REQUEST Current Zoning: B-1(CD) (neighborhood business, conditional)

Proposed Zoning: UR-2(CD) (urban residential, conditional)

LOCATION Approximately 13.01 acres located at the southeast intersection of

The petition proposes development of the site to accommodate a planned multi-family development of 126 duplex units, at a density of 9.7 dwellings per acre (DUA).

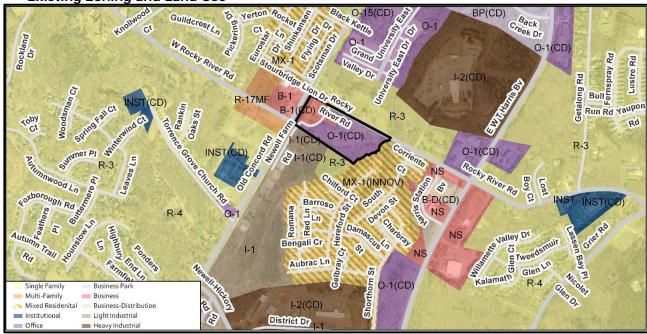
The site plan accompanying this petition contains the following provisions:

- Develops site with a planned multi-family development containing a maximum of 126 duplex units.
- Provides driveway connections to Rocky River Road and constructs a new public street (designated as the University East Collector Road on the rezoning plan).
- Limits the maximum height to 1.5 stories and requires architectural design standards.
- Constructs an 8-foot wide planting strip and 6-foot sidewalk along the site's frontages on Rocky River Road and the University East Collector Road.
- Establishes a minimum 37.5-foot Class A buffer along the Site's southern boundary. The required width of this buffer has been reduced by 25% from 50 feet to 37.5 feet by installation of a berm.
- Dedicates and conveys the 100-foot SWIM buffer of Back Creek located on site to Mecklenburg County for future greenway purposes.

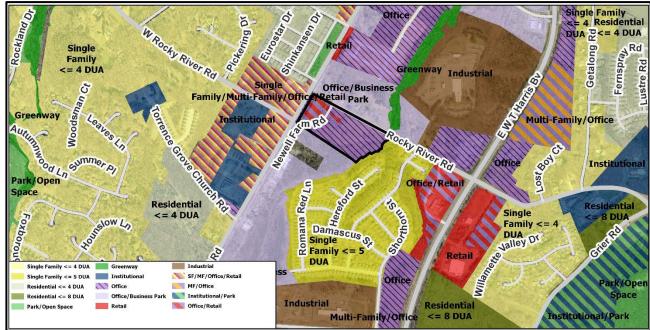
- Curbline: The proposed zoning district has a setback measured from back of the existing or proposed future curbline. The location of the future back of curb is 26 feet from centerline along Rocky River Road to account for minor thoroughfare with buffered bike lane to point shown below (Approximate location, CDOT can work with petitioner with where the intersection will occur). After that point the future back of curb is 13 feet from center line in accordance to CLDS U-02. Per chapter 19 the developer should install curb and gutter as part of this development.
 - a.—Revise the site plan to include a typical for Rocky River Road.
 - b.—Revise the site plan to clearly dimension the curb and gutter from the centerline of the
 - c. Revise the site plan to clearly show curb and gutter along Rocky River Road. Addressed

- Revise the site plan and conditional note(s) to commit to constructing a public road to meet the
 intent of the Minor Thoroughfare road right-of-way through the site as prescribed by the
 Comprehensive Transportation Plan approved by the Charlotte Regional Transportation Planning
 Organization. The cross-section should match what was previously approved be development
 north of site as shown below.

- a.—The 36 feet of pavement will be used for future travel lanes. Revise the site plan due to proposed on-street parking on University East Extension based on the following options:

- i.—Place on-street parking outside of the 36 feet.
 - ii. Remove bulb-outs at intersections to allow future travel lanes. This would allow on-street parking on the road, but it can't count as required site parking. In addition, note C3 should remove, "on-street parking shall be allowed on the University East Collector Road."

- b.—Revise the site plan to include a typical for University East Extension.
 - e.—Revise the site plan to clearly dimension the curb and gutter from the centerline of the road.

- d. Revise the site plan to graphically show curb and gutter along University East Extension.
